APPLICATION NO.	FILING DATE	FIRST NAMED INVENTOR	ATTORNEY DOCKET NO.	CONFIRMATION NO.
10/560,588	12/12/2005	George Marmaropoulos	US030177US	7162
24737 7590 08/29/2007 PHILIPS INTELLECTUAL PROPERTY & STANDARDS P.O. BOX 3001 BRIARCLIFF MANOR, NY 10510			EXAMINER TSUKERMAN, LARISA Z	
			ART UNIT 2833	PAPER NUMBER
			MAIL DATE 08/29/2007	DELIVERY MODE PAPER

Office Action Summary	Application No.	Applicant(s)	
	10/560,588	MARMAROPOULOS ET AL.	
	Examiner	Art Unit	
	Larisa Z. Tsukerman	2833

DETAILED ACTION

Attachment

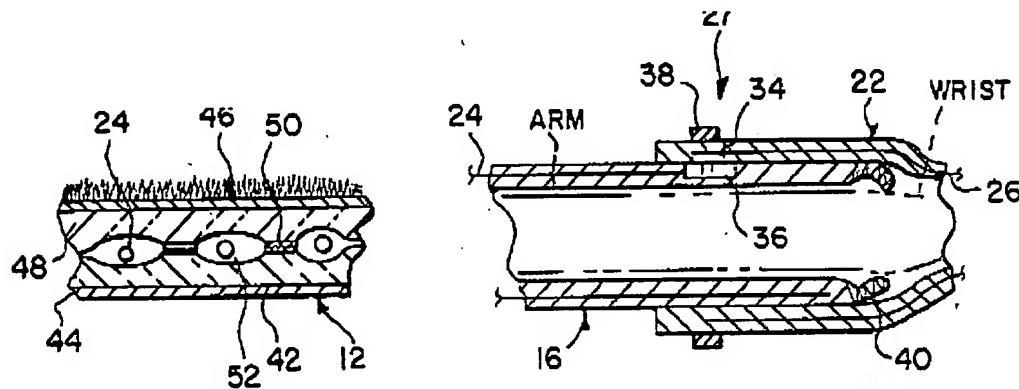
Claim 1 is rejected under 35 U.S.C. 102(b) as being anticipated by Nash et al. (4777344).

In regard to claim 1, Nash et al. disclose a fabric interconnect (not marked, see Fig.4) for use to interconnect a garment 22 (glove) having fabric electrodes 26 and an electronics enclosure 16/10 having a conductive area 24/36 on its outer surface that is connected to a circuit (see Fig.1), the fabric interconnect comprising: a portion (not marked, see Fig.4) of the garment 22 including a first inner surface FIS26 (see Attachment), which is substantially electrically conductive, coupled to the fabric electrodes 26; and a second inner surface that is substantially electrically non-conductive 34, wherein the first inner surface FIS and the second inner surface 34 are

seamlessly manufactured to form a chamber C, and wherein when the electronics enclosure 16/10 is inserted into the chamber C in a predetermined position, causes the conductive area of the electronics enclosure 24/27 and the first inner surface FIS26/27 to make contact and form an interconnection between the fabric electrodes of the garment and the circuit.

a first inner surface FIS26 chamber C
